SERVICE BULLETIN

02-150

Model 579 Battery Box Road Debris Closeout

8/22/2019

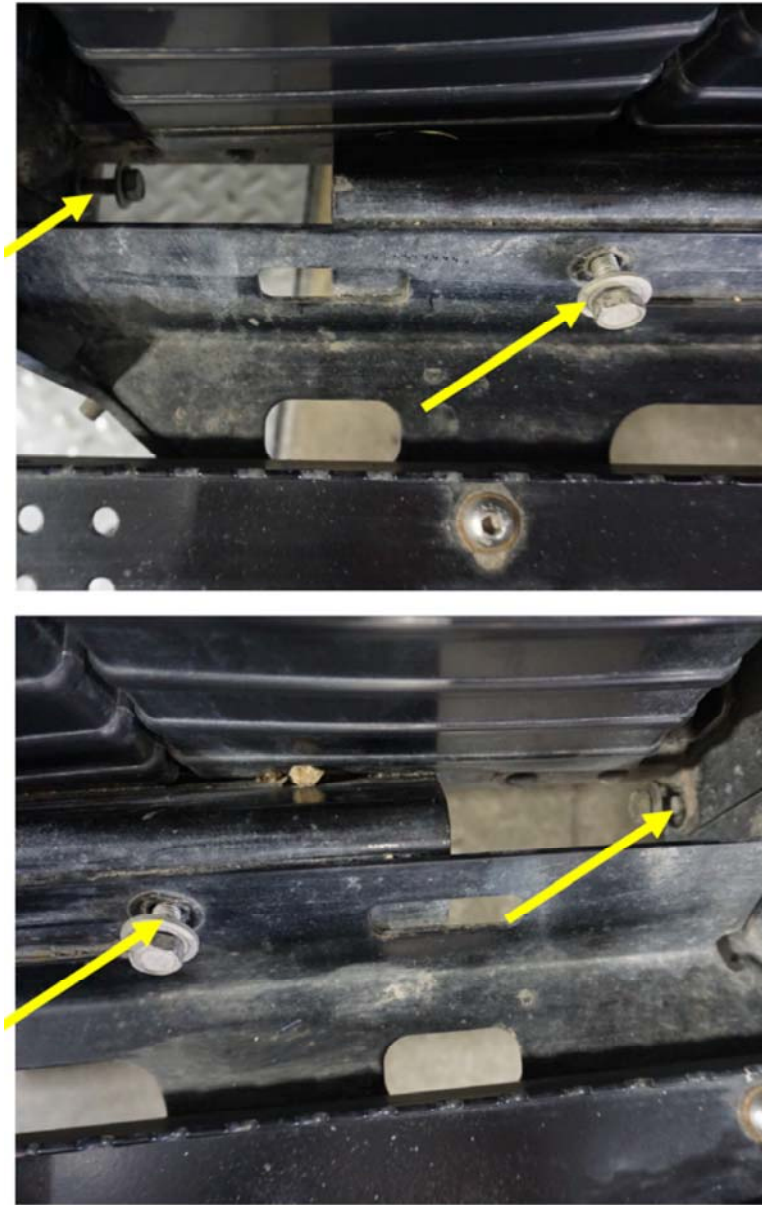
Peterbilt has determined that certain model 579 trucks, built from 11/03/2014 to 7/29/2019 and equipped with chassis fairings, were built with battery boxes that have openings near the step support. These openings can allow road debris to enter the box.

If a customer comes into your dealership and demonstrates the condition above, add the closeout that has been designed to cover these openings.

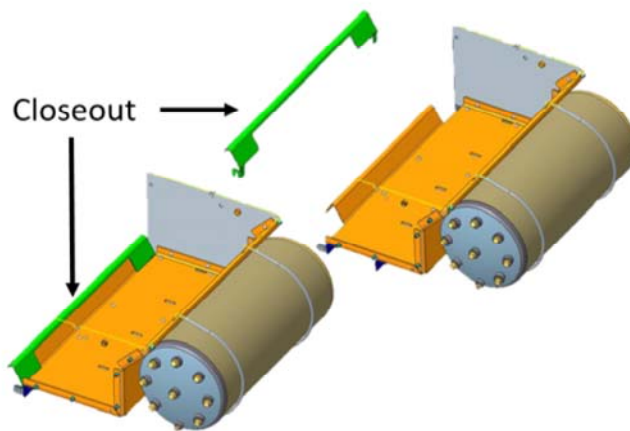
1. Remove the battery box cover.
2. Remove the four bolts shown below.

3. Install the closeout and reinstall the 4 bolts.
